UNITED STATES PATENT AND TRADEMARK OFFICE

Office Action Summary

10/521,573

5/8

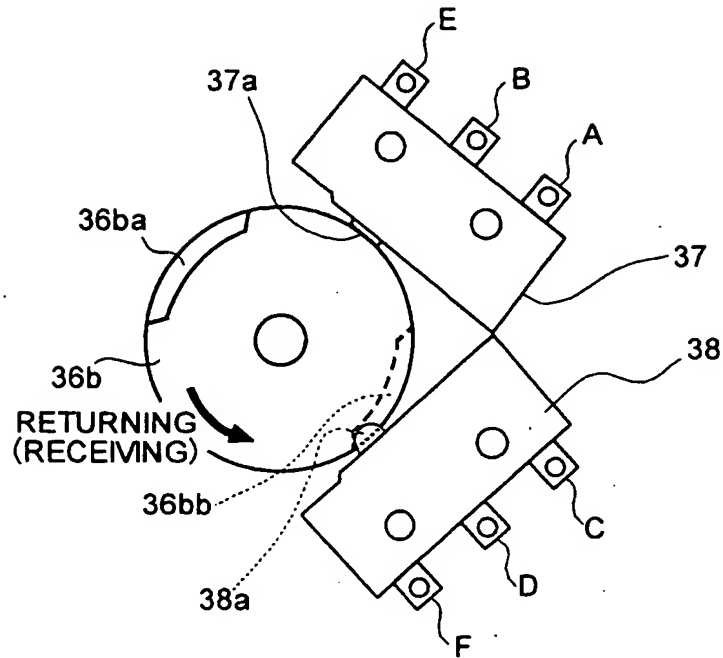
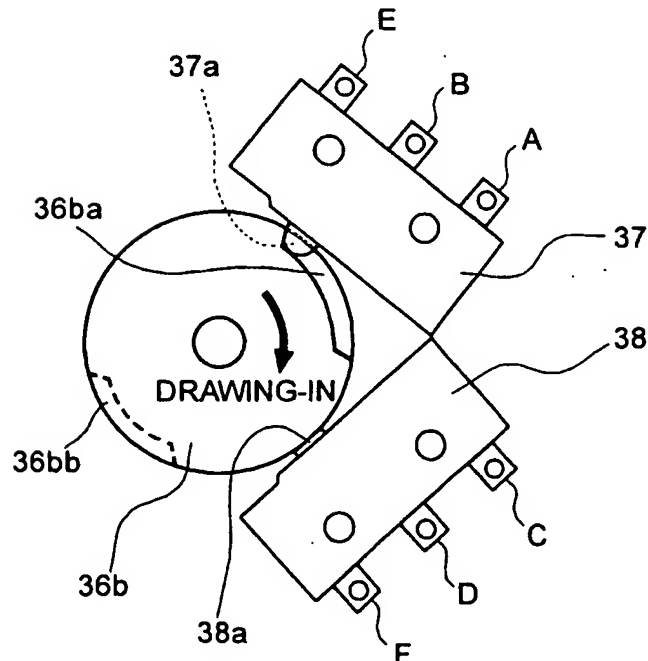
The drawing correction dated 1/18/2005 has been approved by the Examiner.

Approved
1/4/2008
